**MEIJER RHH**  
**1495 N. ROCHESTER RD.**  
**ROCHESTER HILLS, MICHIGAN 48307**  
 (APPROX. 3.92 ACRES) LOCATED IN THE CITY OF ROCHESTER HILLS, COUNTY OF OAKLAND, AND STATE OF MICHIGAN

**ROCHESTER HILLS MICHIGAN**  
**J2024-0177**  
**PSP2024-0026**  
 Original Submission  
 Received 8/2/2024  
**City of Rochester Hills Planning & Economic Development**

**Site Plan Review**  
 Reviewed for compliance with City Ordinance, Building and Fire Codes  
 Conditions and mark-ups noted throughout plan set must be addressed prior to final approval

**USE DESCRIPTION: CONDITIONAL USE**  
**AND SITE PLAN REVIEW**  
**DATE: 08/02/2024**  
**PROJECT NUMBER: TBD**

1459 N. Rochester Road  
 Rochester Hills, MI 48307  
 PID: 15-10-226-041

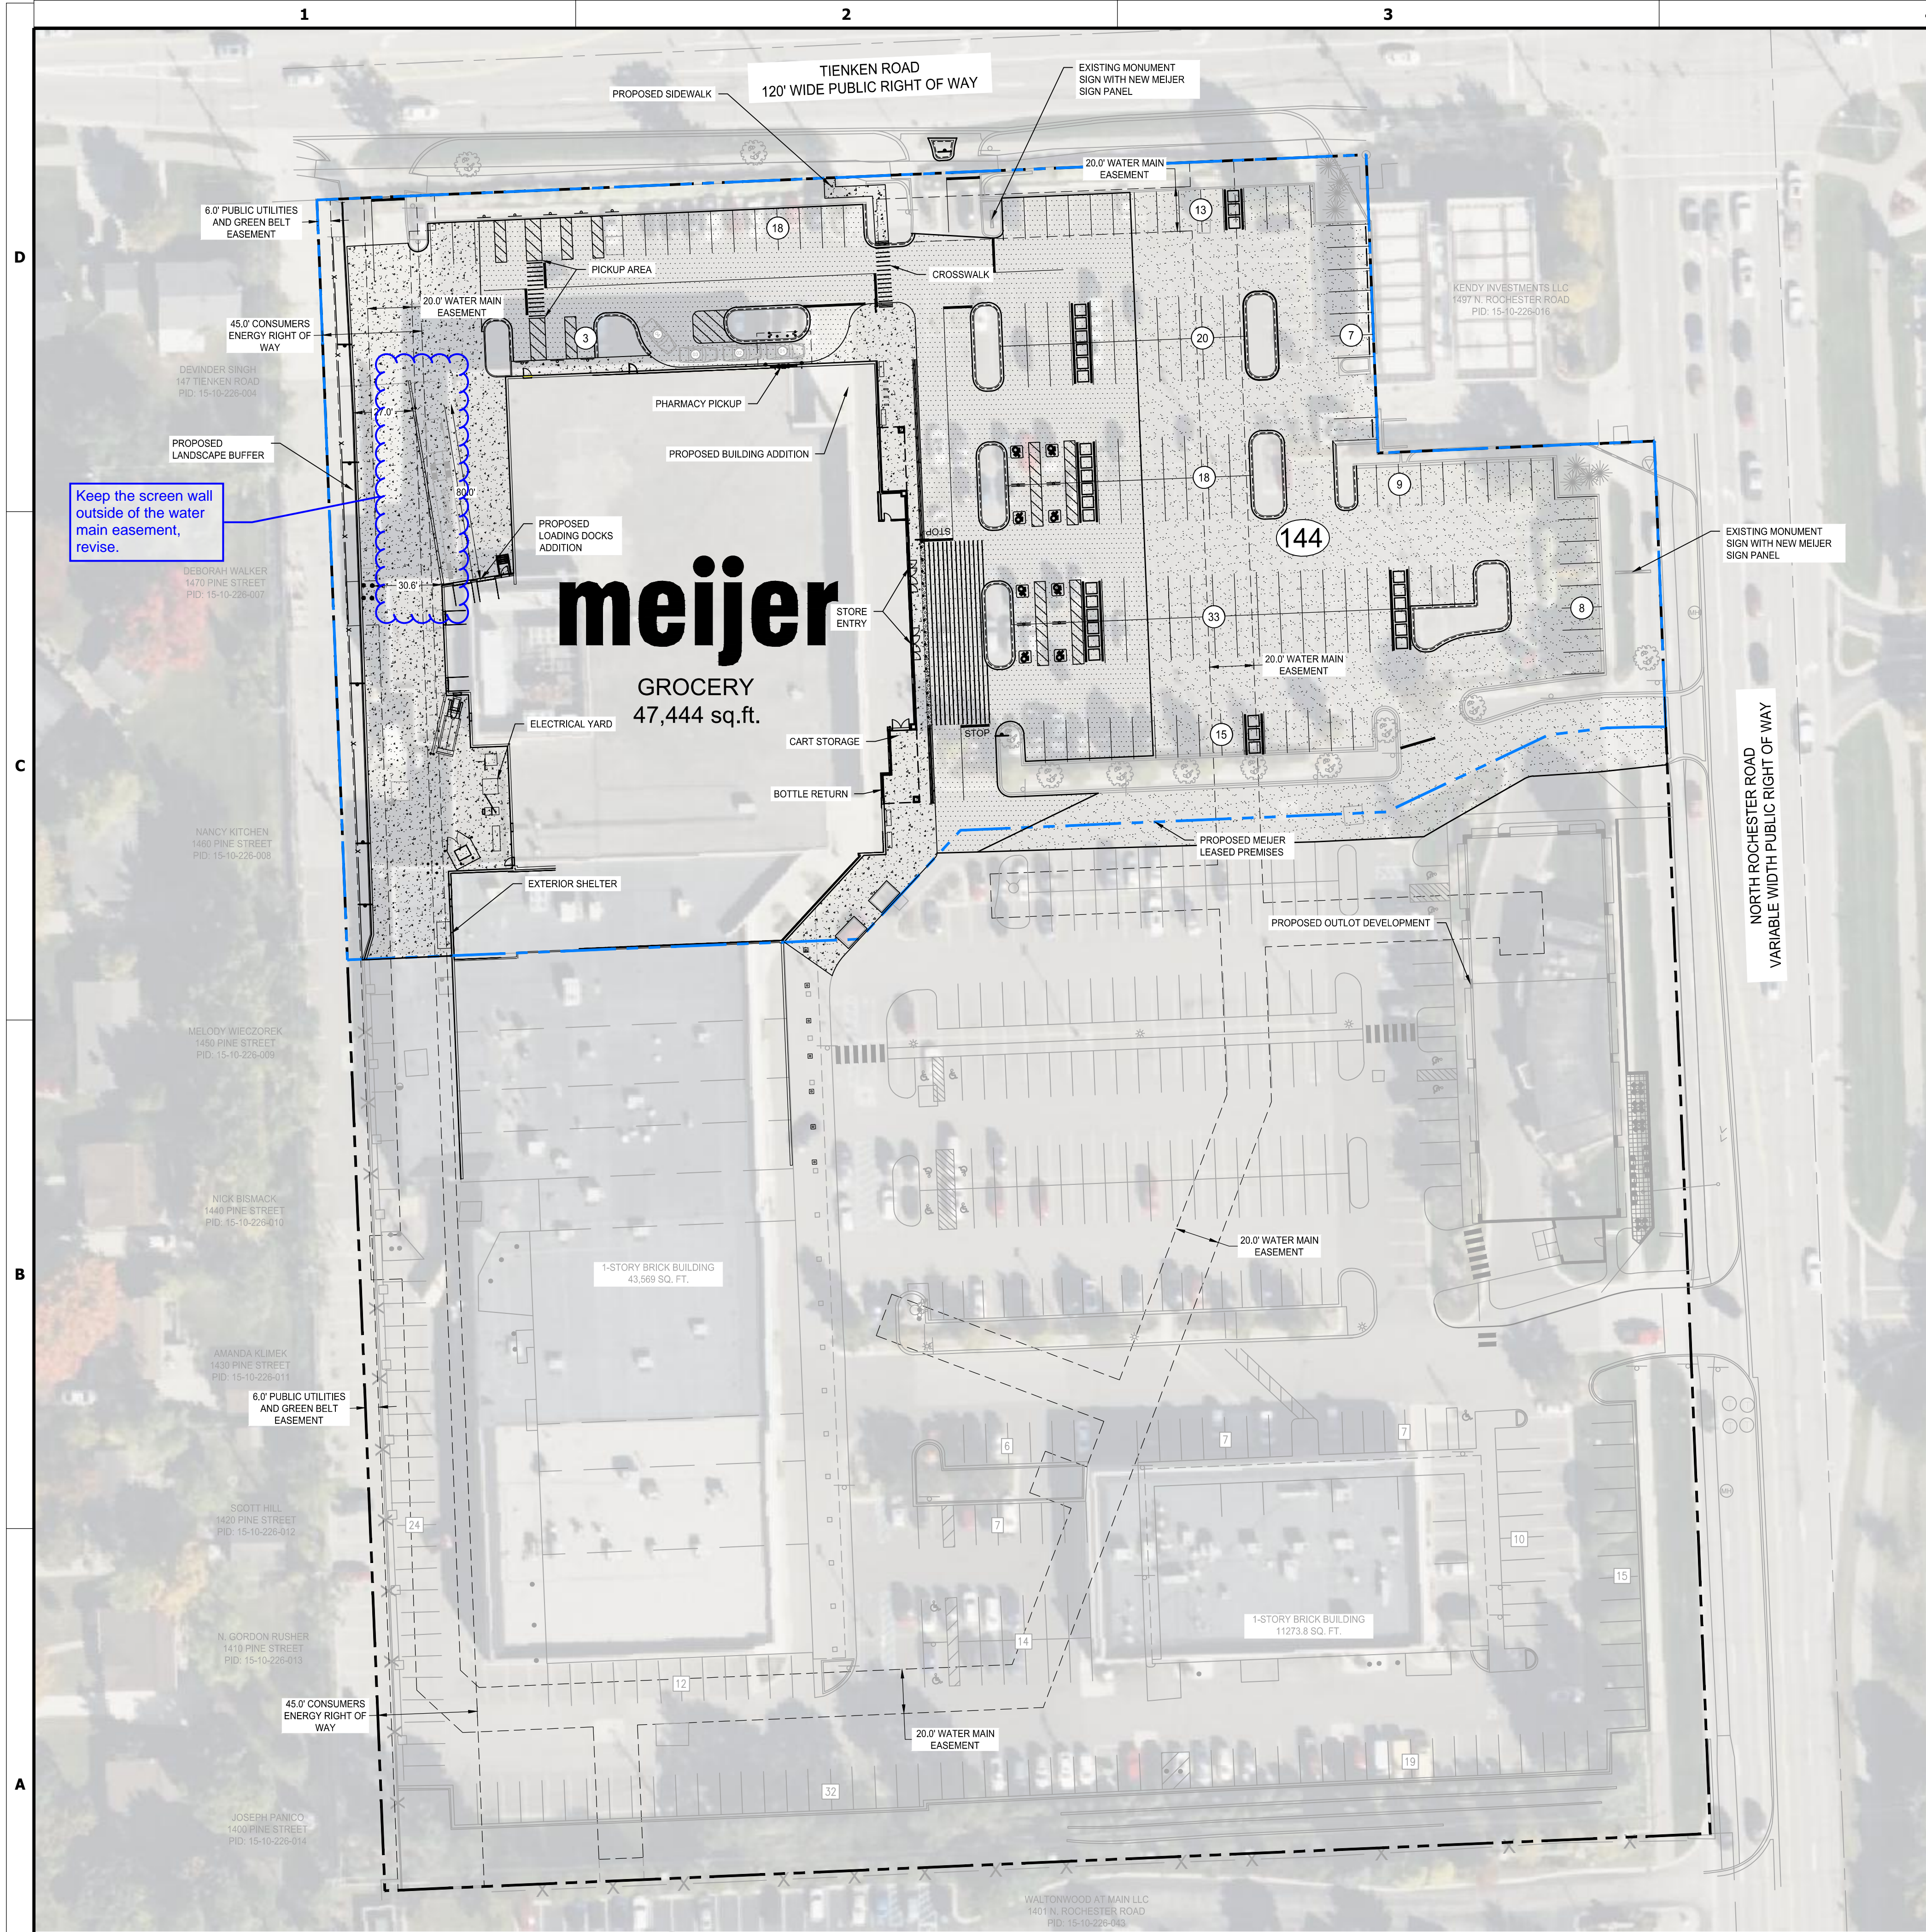
Include a parcel ID with description.

**A1 MEIJER SITE LAYOUT / PAVEMENT PLAN**  
1" = 30'

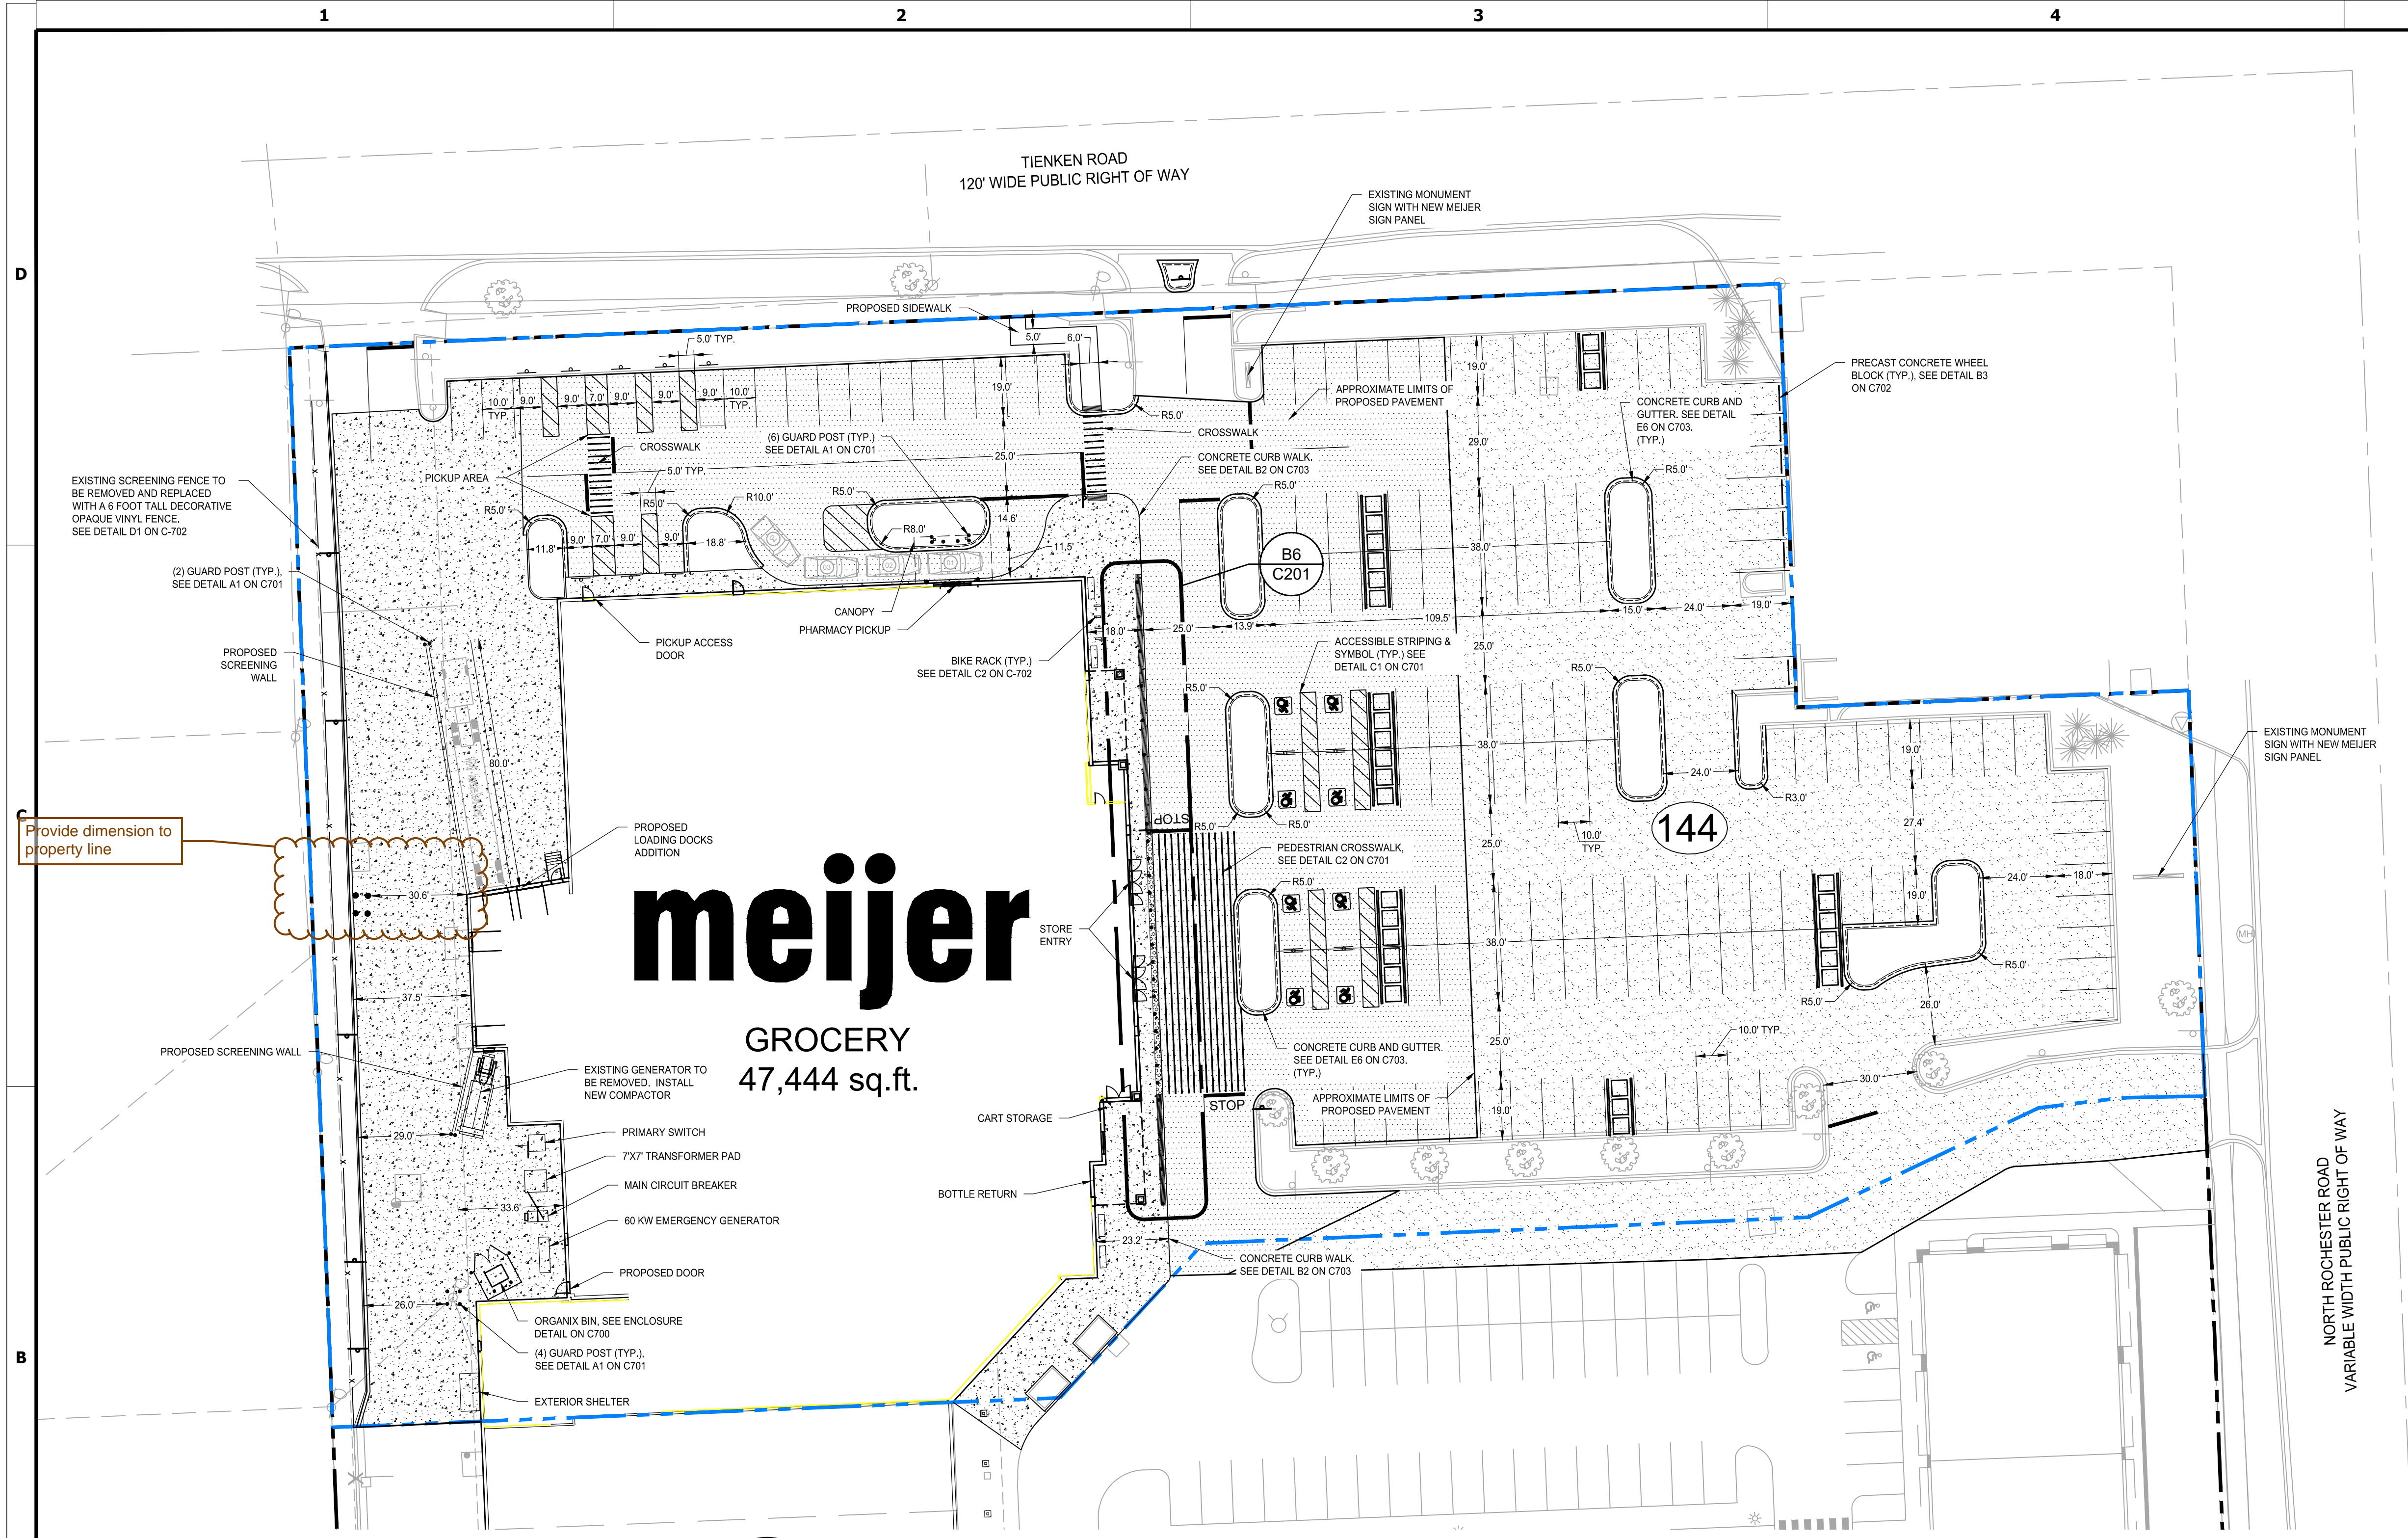
Provide dimension to property line

A1 LANDSCAPE PLAN  
1" = 30'

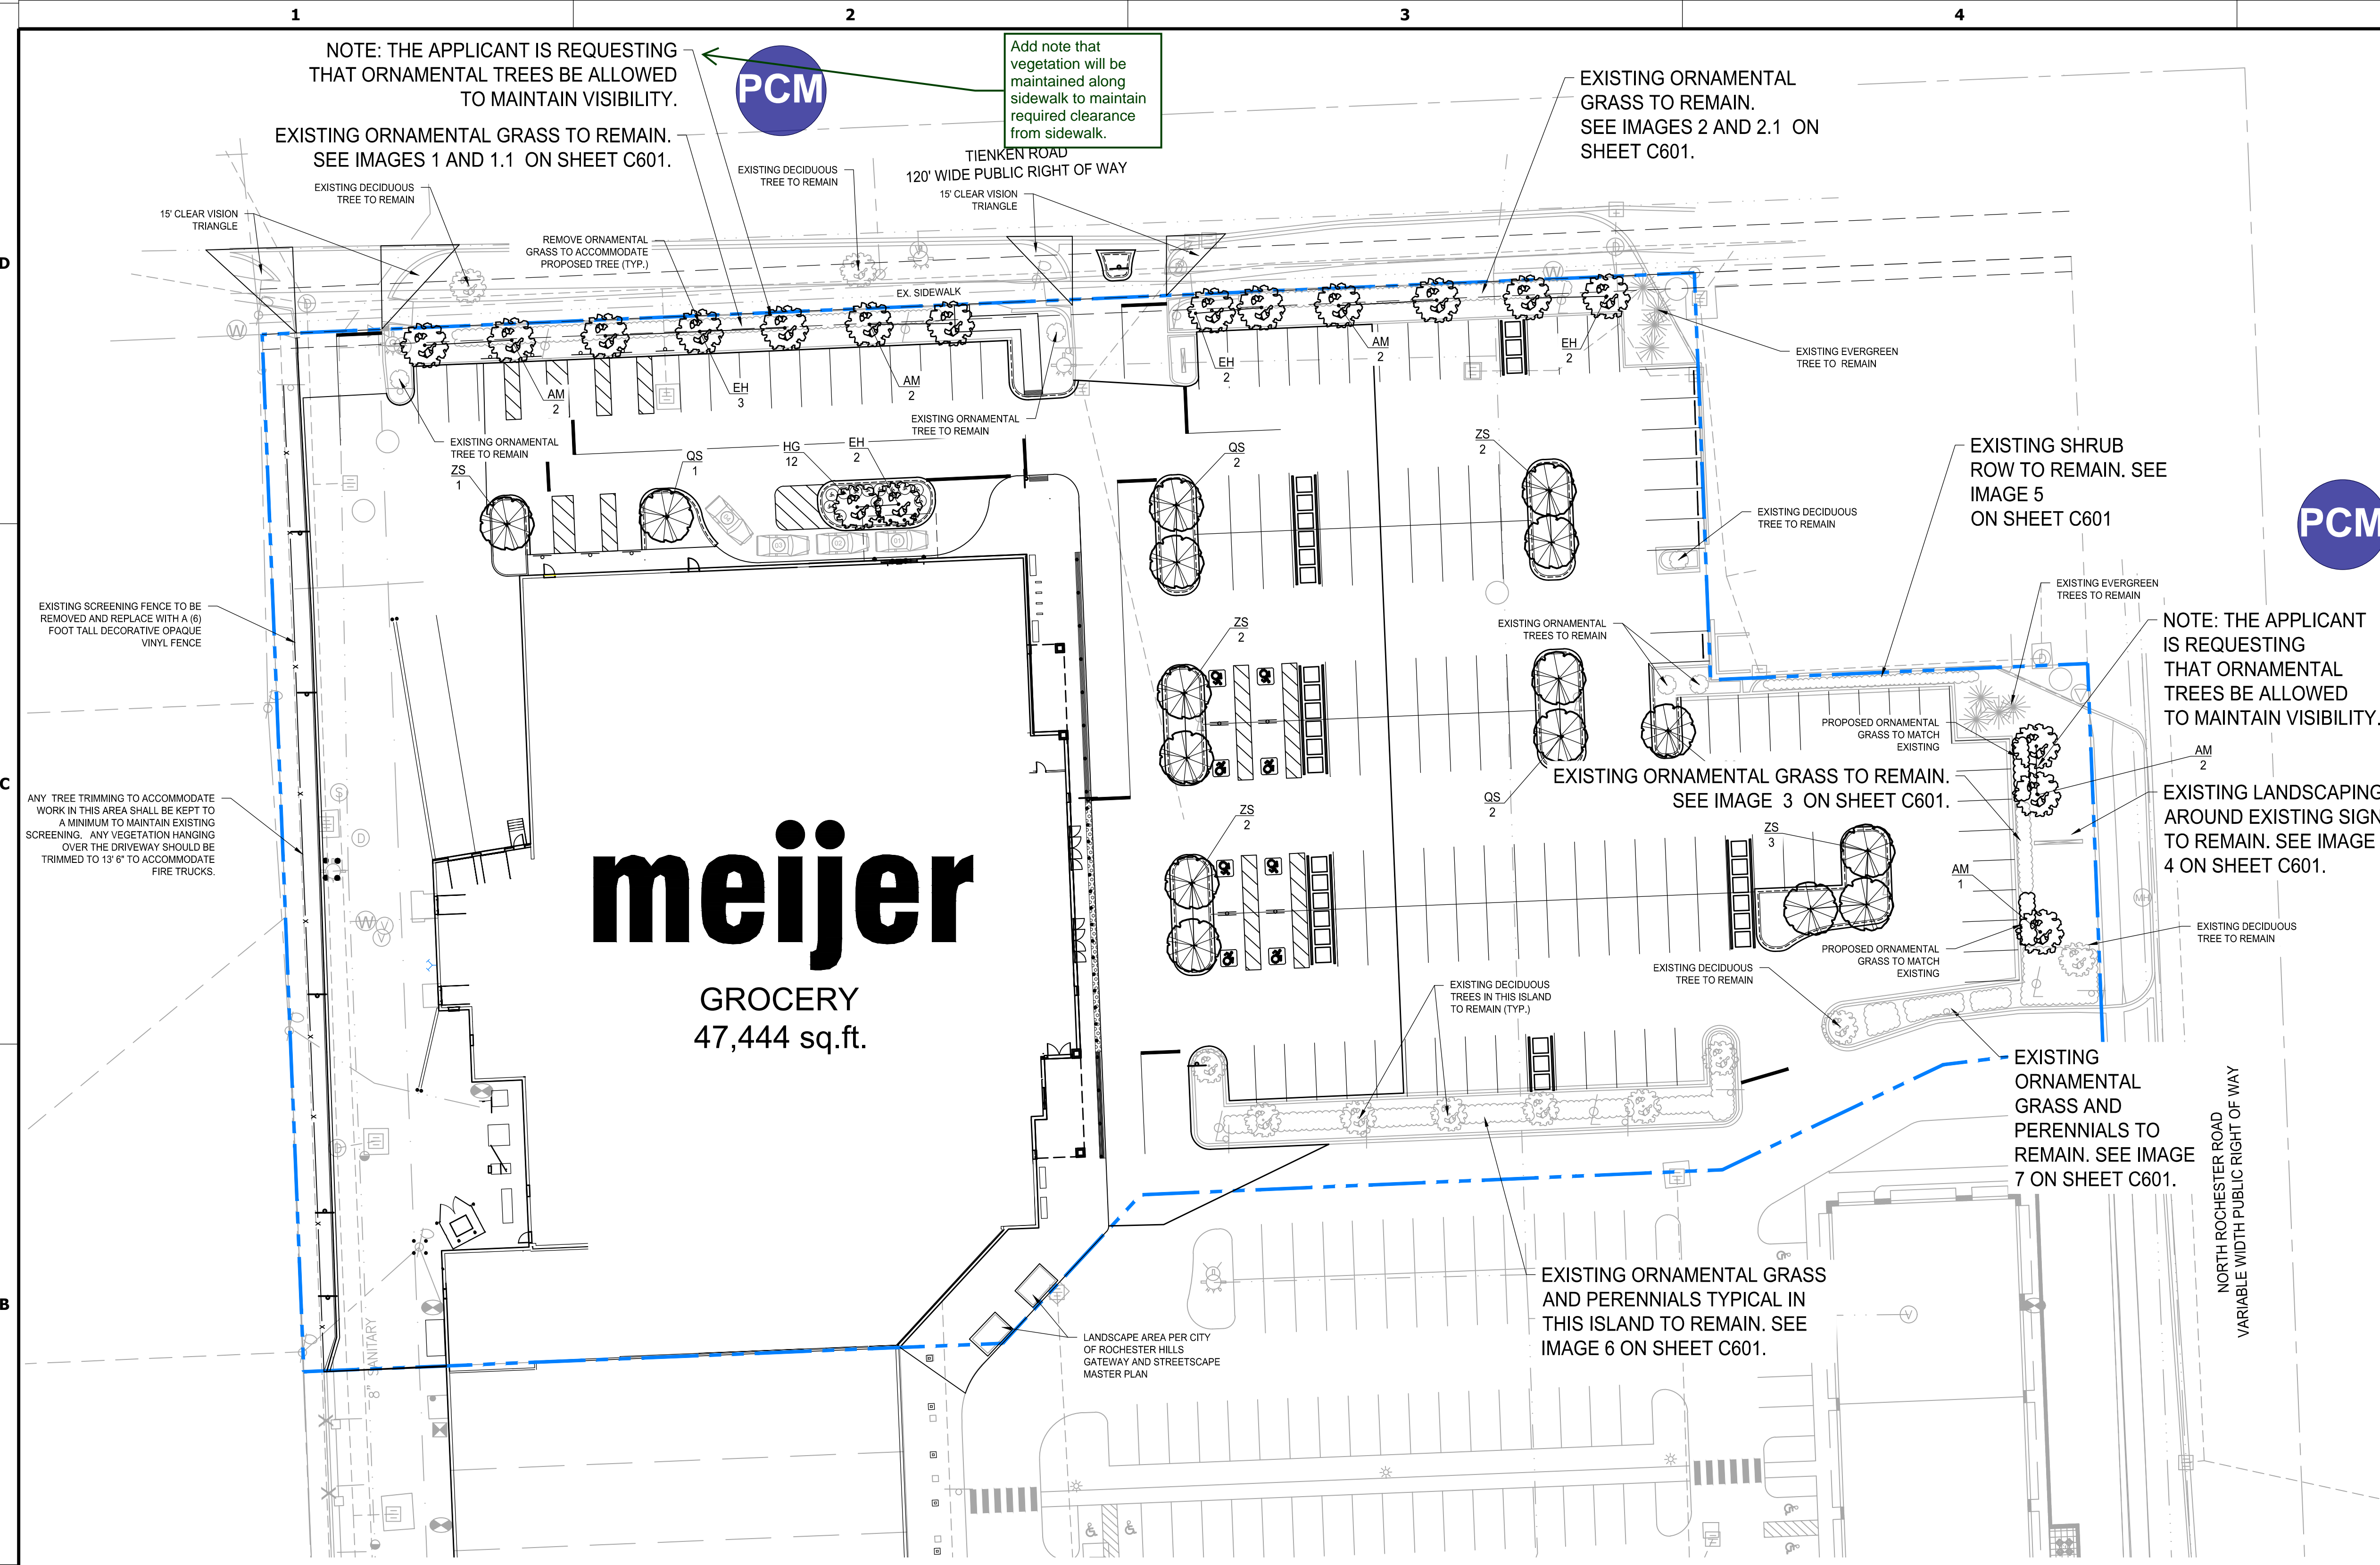
Provide landscaping cost estimate including irrigation
